FROM: Carolina Power & Light Company Raleigh, N. C. 27602 E. E. Utley			DATE OF DOC 10-23-73	DATE REC'D 10-29-73	LTR X	MEMO	RPT	OTHER
TO: J. F. O'Leary			ORIG 3 signed	CC	OTHER	SENT AEC PDR X SENT LOCAL PDR X		
CLASS	UNCLASS XXXX	PROP INFO	INPUT	NO CYS REC'D 40		DOCKET NO: 50-261		
DESCRIPTION: Ltr requesting change in Tech Specs, regarding current precautions, Limitations & Setpoints... .....w/ATTACHED ( table 3.5-1 )				ENCLOSURES:				
PLANT NAME: H. B. Robinson Unit 2

H. B. ROBINSON UNIT NO. 2

LICENSE DPR-23

TECHNICAL SPECIFICATIONS CHANGE REQUEST

SETPOINTS AND  $\Delta P$  FOR STEAM FLOW

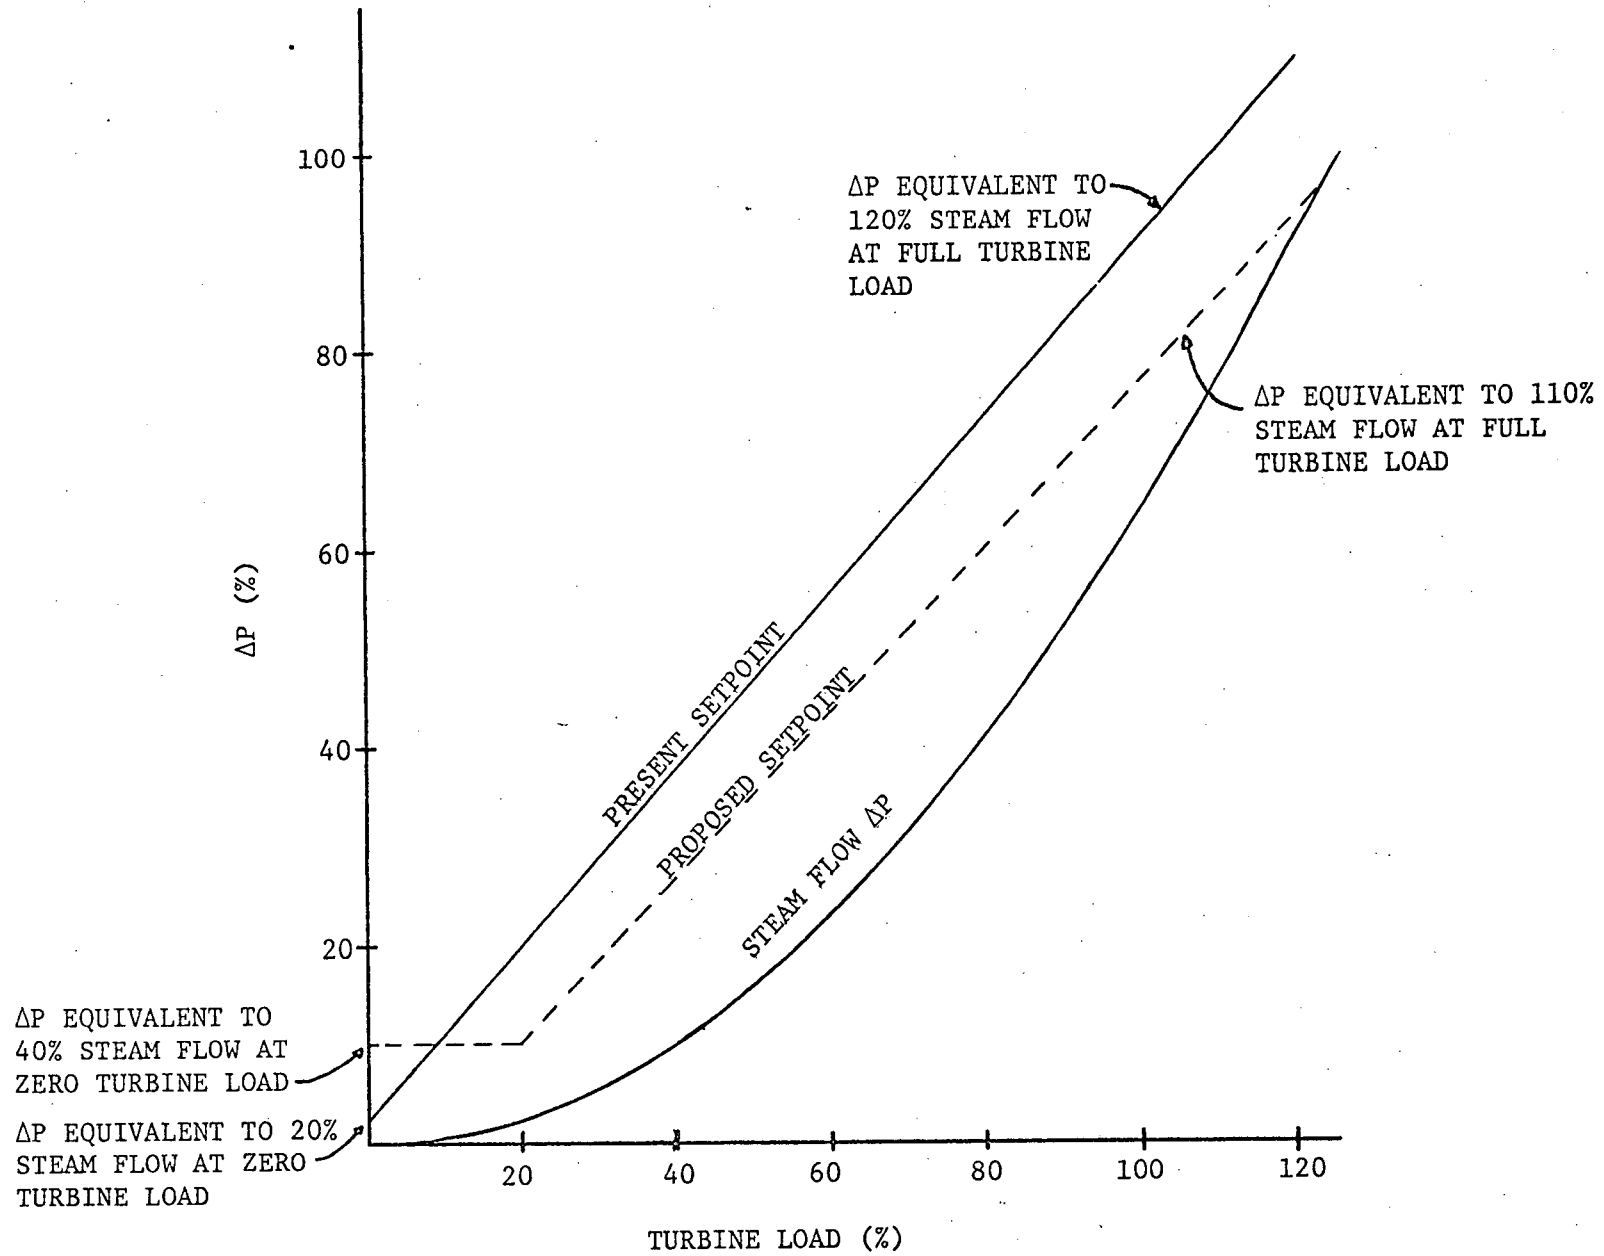
In the operation of the Robinson Plant, we have experienced spurious safety injections during plant shutdown and startup due to steam line flow differential pressure signal variations caused by instrument drift at very low power levels. A recent letter from the reactor vendor, Westinghouse, states that other Westinghouse PWR plants have had similar problems.

The current "Precautions, Limitations and Setpoints" document and the Technical Specifications set the limiting values at a differential pressure equivalent to 20% above the normal steam flow values at zero and full turbine load. A flow exceeding this condition coincident with either a "Low Tavg," or a "Low Steam Line Pressure" will actuate safety injection.

To eliminate the problem of spurious safety injection actuations during plant startups or unloadings, Westinghouse has developed a new "High Steam Flow" setpoint curve which can be accommodated by the present hardware (see figure). The setting for the differential pressure would be a constant from zero to 20% turbine load and a linear function from 20% to 100% turbine load. The zero and 20% load settings would represent a differential pressure equivalent to 40% steam flow at zero load steam pressure; the 100% load setting would represent a differential pressure equivalent to 110% steam flow at 100% load steam pressure. This new setting would be more conservative than the current values throughout the higher load range while through low and zero load conditions the new setpoints will be outside the range of normal differential pressure signal variation and will therefore eliminate spurious actuation of safety injection. This change does not affect the results of steam line break analyses of the Final Safety Analysis Report or the Fuel Densification Report for H. B. Robinson Unit No. 2.

3.5 Under Setting Limits, change the first sentence of Paragraph 5 on Page 3.5-4 to read as follows: "The high steam line flow limit is set at approximately 40% of the steam flow from no load to 20% load and at 110% of full steam flow at full load, with the steam flow differential pressure measurement linearly programmed between 20% load and 100% load in order to protect against large steam line break accidents."

<u>"No.</u>	<u>Functional Unit</u>	<u>Channel Action</u>	<u>Setting Limit</u>
5	High Steam Flow in 2/3 Steam Lines	a. Safety Injection* b. Steam Line Isolation	<ΔP Equivalent to 40% of full steam flow (at zero load), <ΔP equivalent to 40% of full steam flow (at 20% load), <ΔP equivalent to 110% of full steam flow (at full load), ΔP Linear from 20% to 100% load.
	Coincident with Low Tavg or Low Steam Line Pressure		>541°F Tavg >600 psig steam line pressure"
